Preliminary Structural Checksheet Response

Permit #: 15-248958-DFS-01-CO

LEVEL 01 BCI JOIST LAYOUT
FILE: 16-001323 JOB: DOZER CONSTRUCTION
FENWICK APARTMENTS

DOZER CONSTRUCTION
FENWICK APARTMENTS
MILWAUKIE LUMBER - STARK
Level 01
Boise Cascade BMD
Vancouver, WA

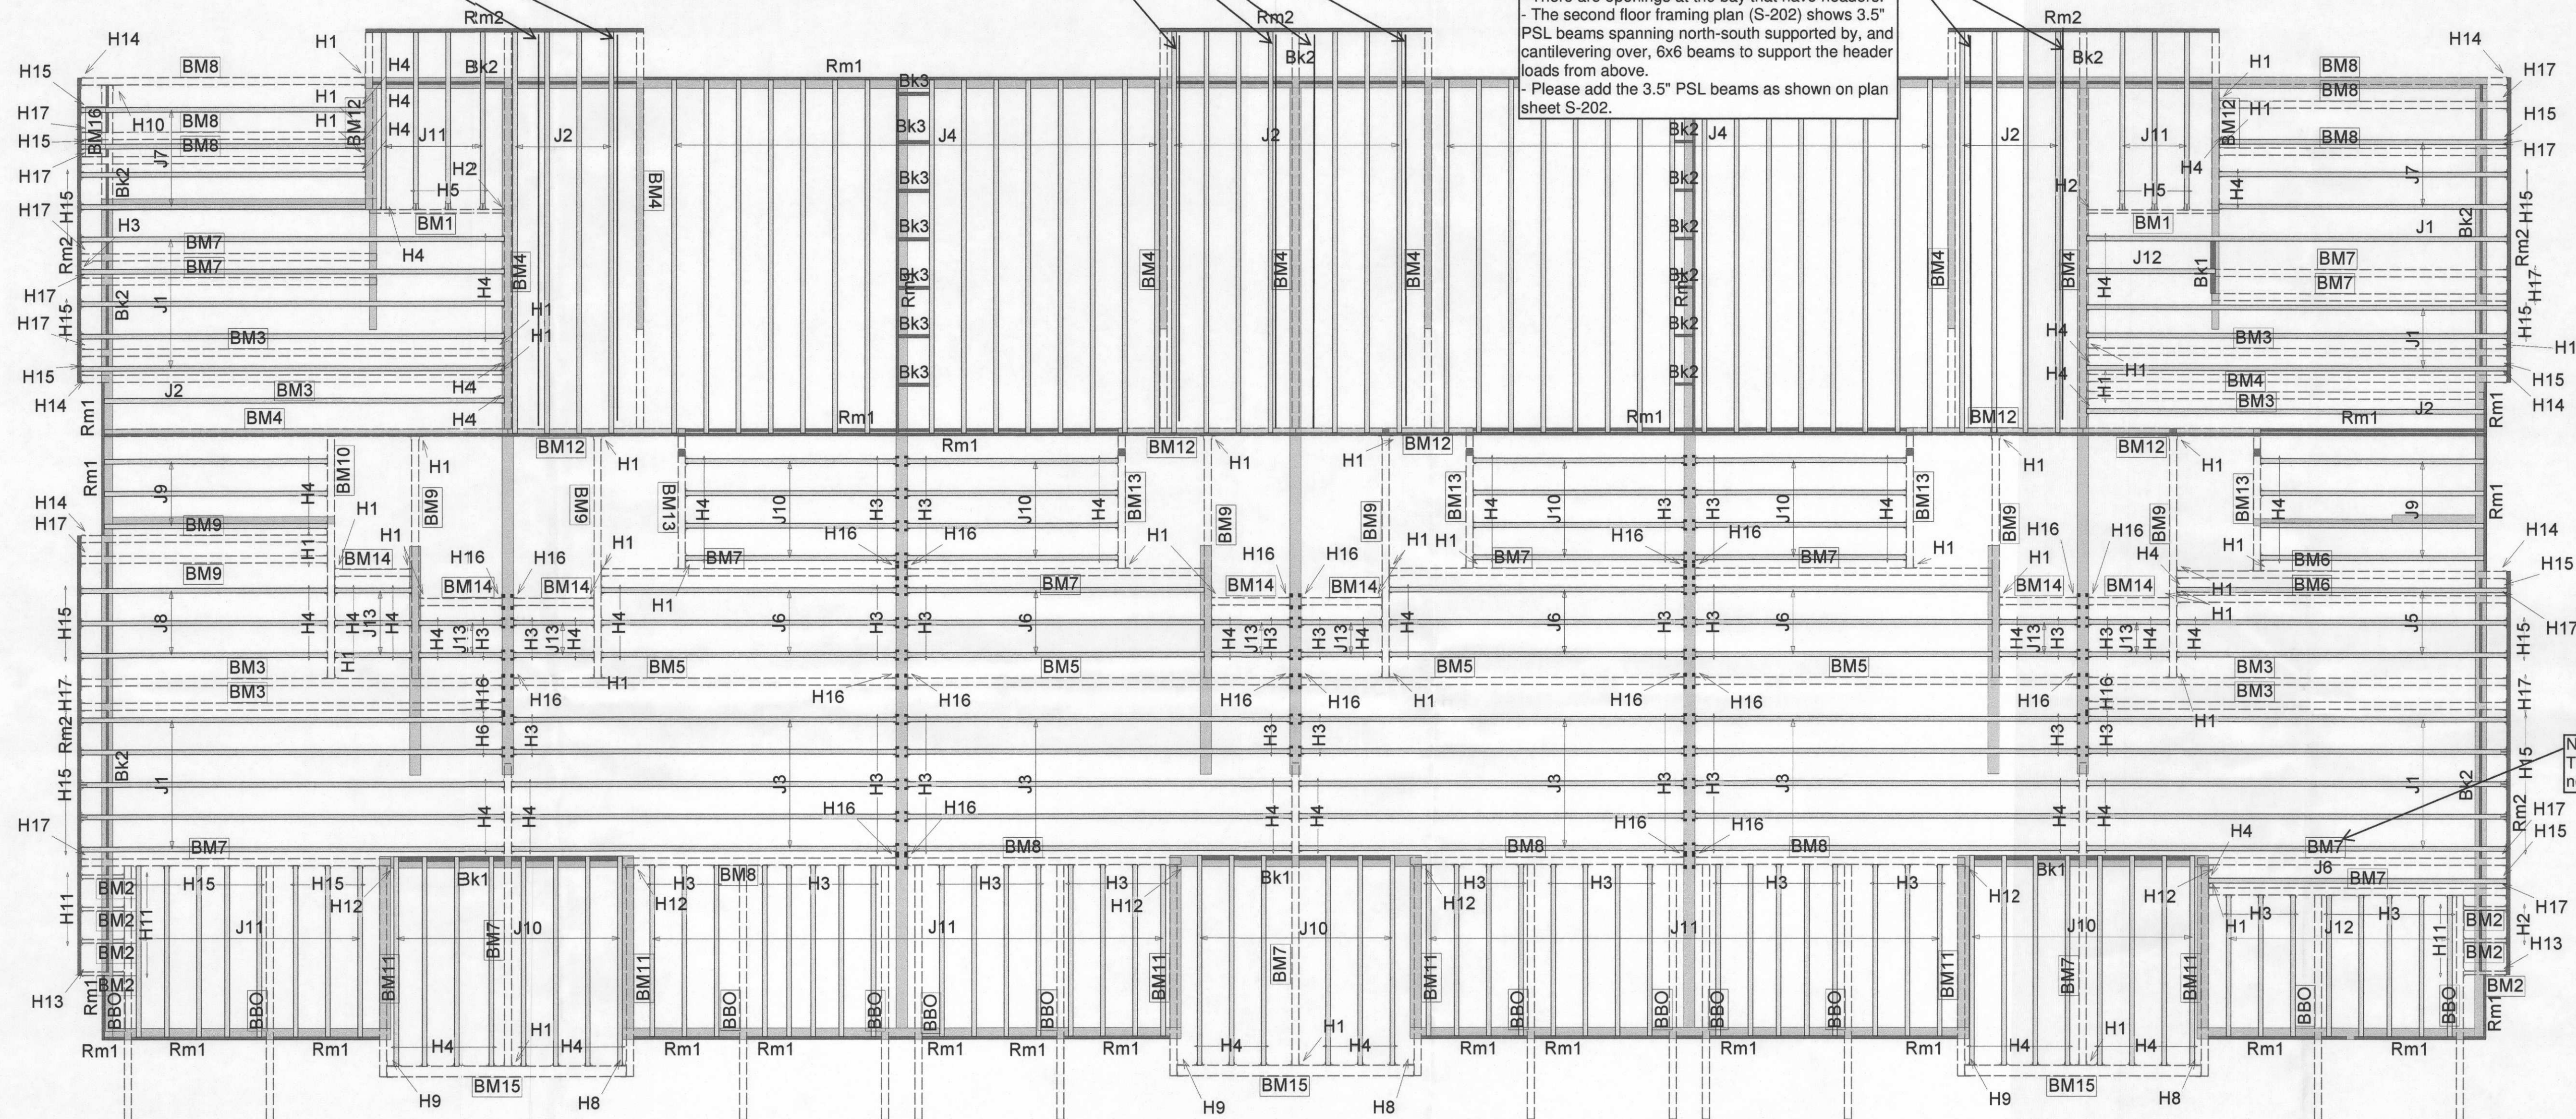
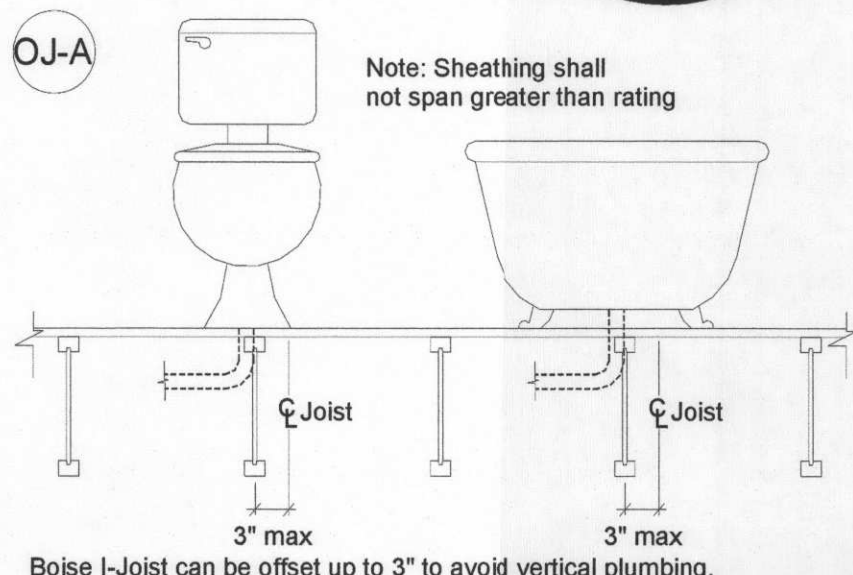
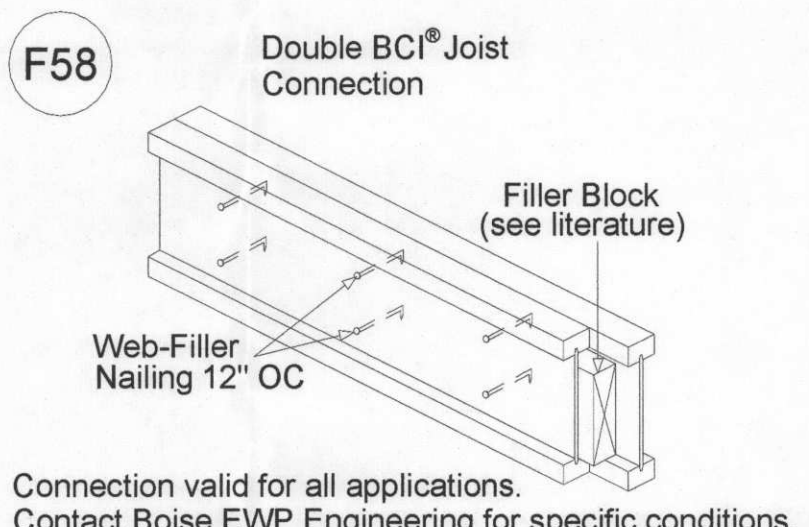
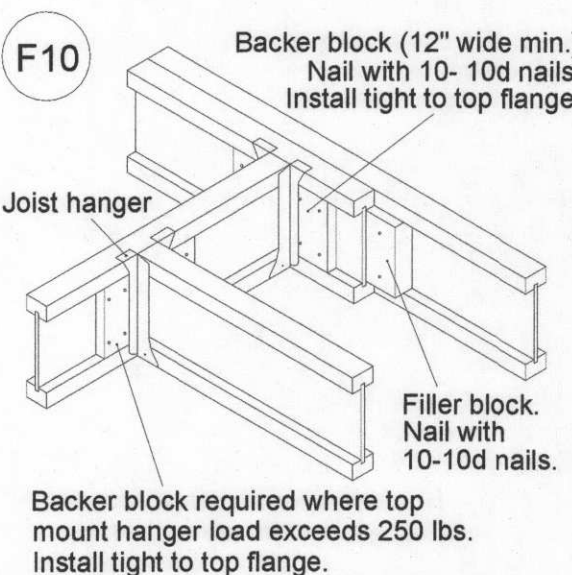
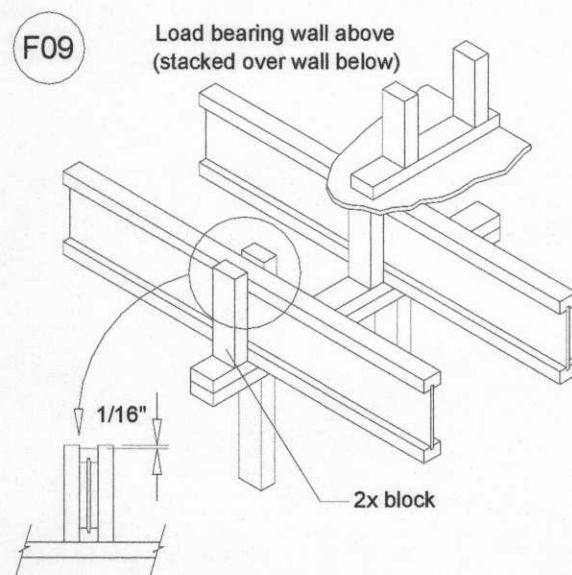
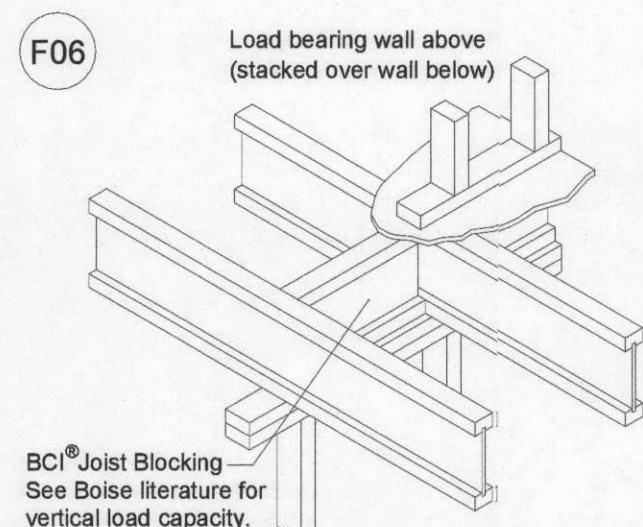
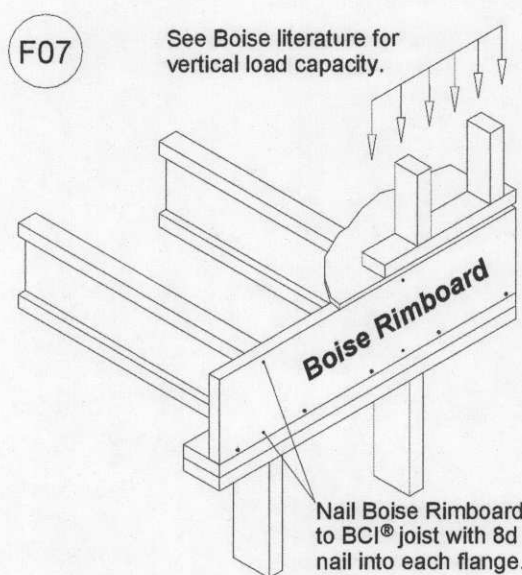
Please Note :
- At the third floor framing plan (S-203) the floor joists span to, and are supported by, the north bay wall.
- There are openings at the bay that have headers.
- The second floor framing plan (S-202) shows 3.5" PSL beams spanning north-south supported by, and cantilevering over, 6x6 beams to support the header loads from above.
- Please add the 3.5" PSL beams as shown on plan sheet S-202.

Note :
This beam does not appear to be necessary, per plan sheet S-202.

UPPER LEVEL BCI JOIST LAYOUT
FILE: 16-001323 JOB: DOZER CONSTRUCTION
FENWICK APARTMENTS

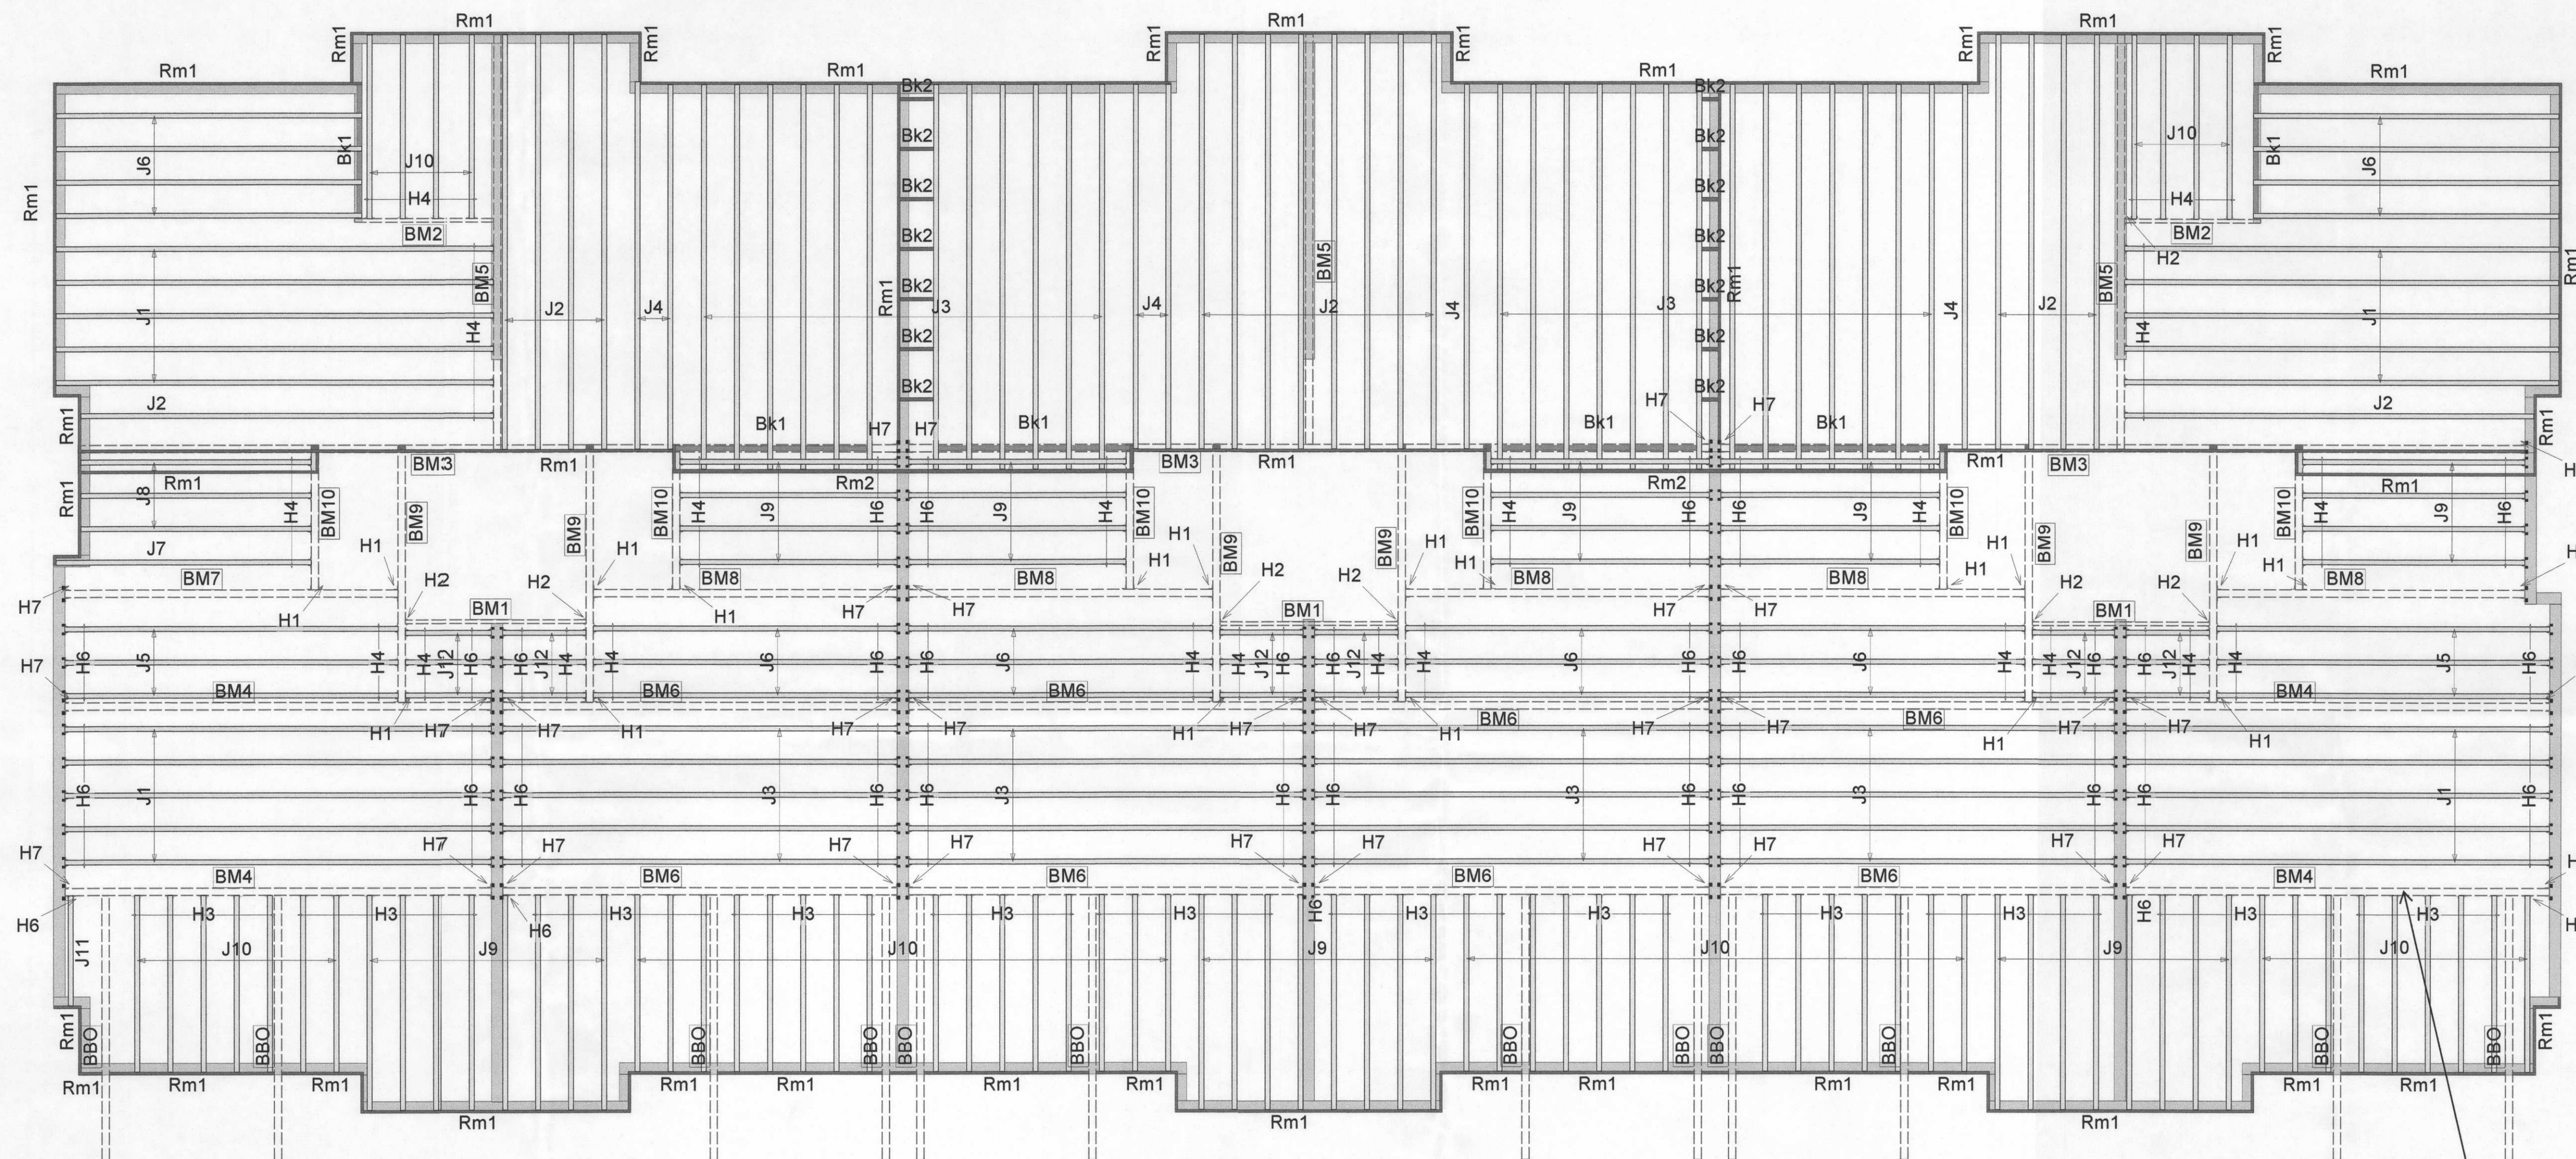
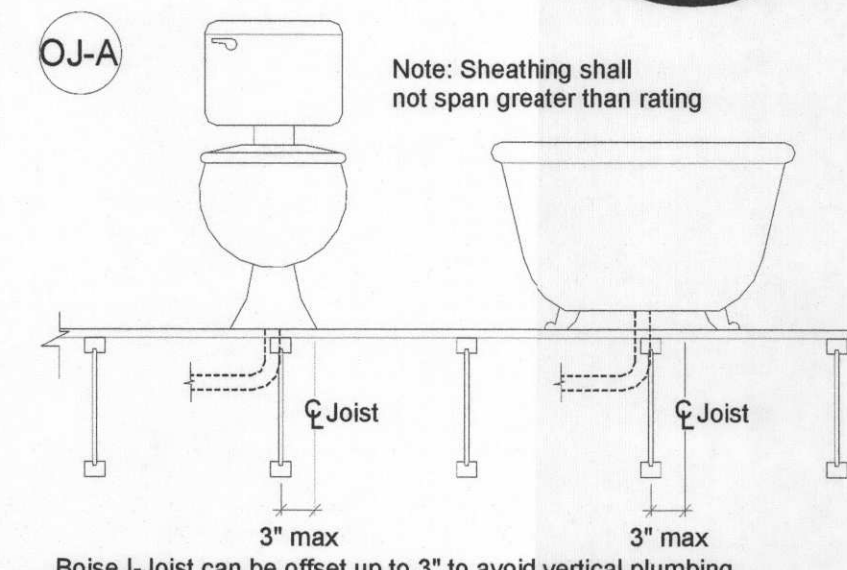
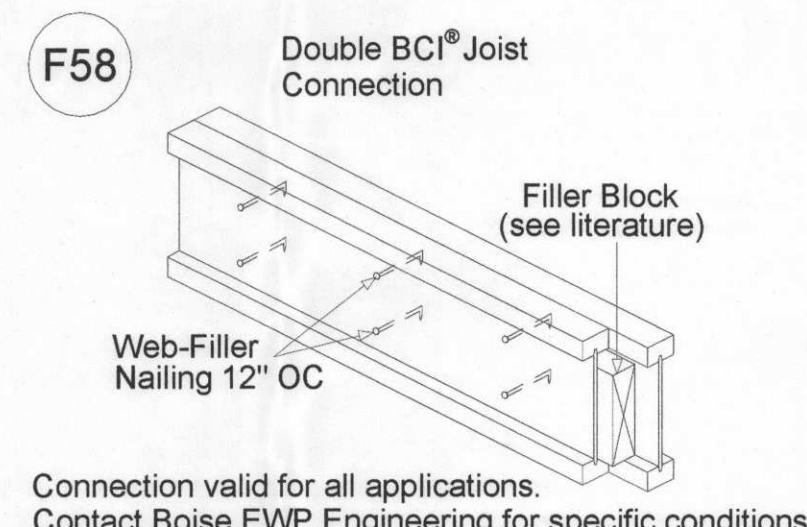
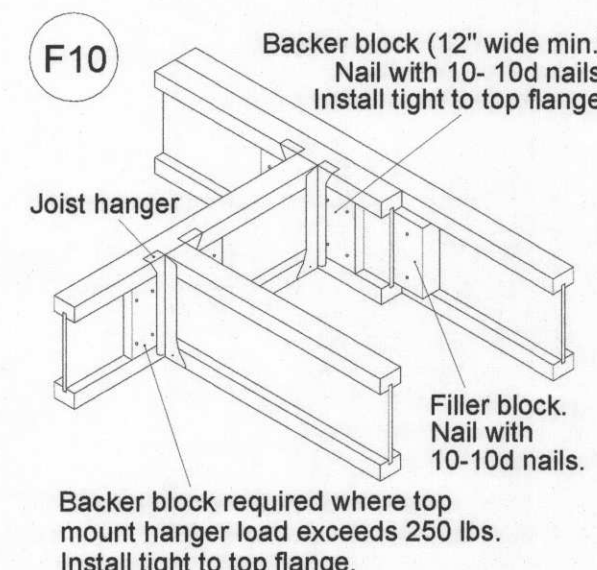
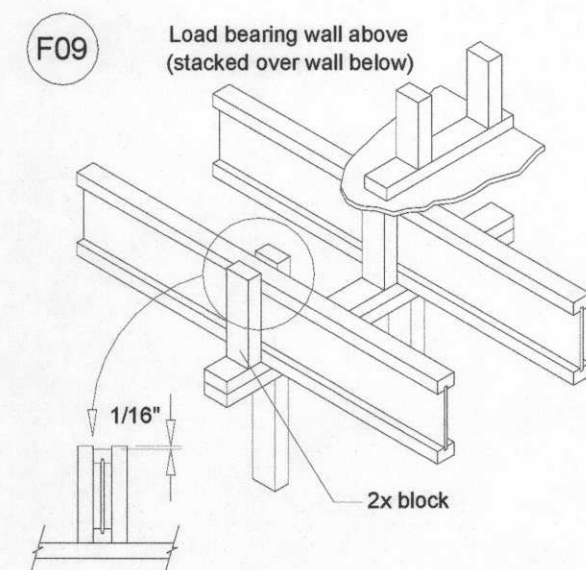
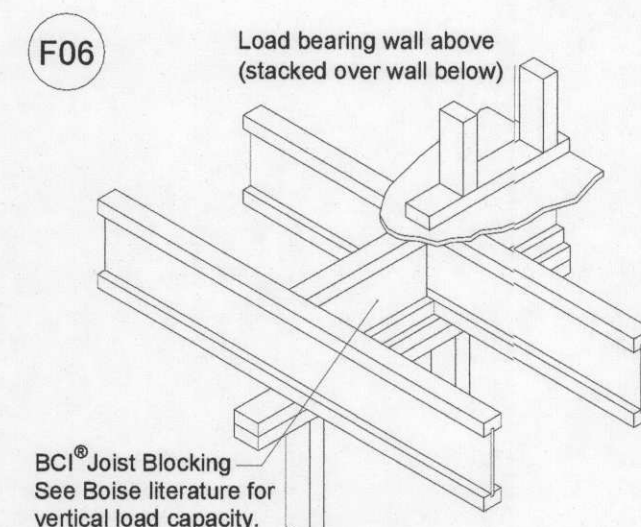
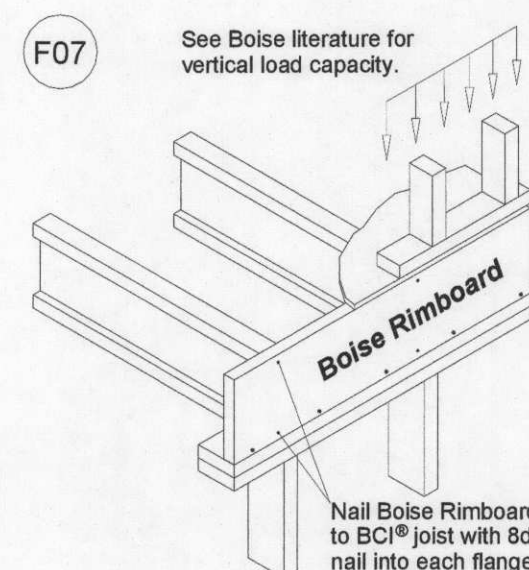
Beam appears to be incorrectly located. Refer to plan sheet S-203.
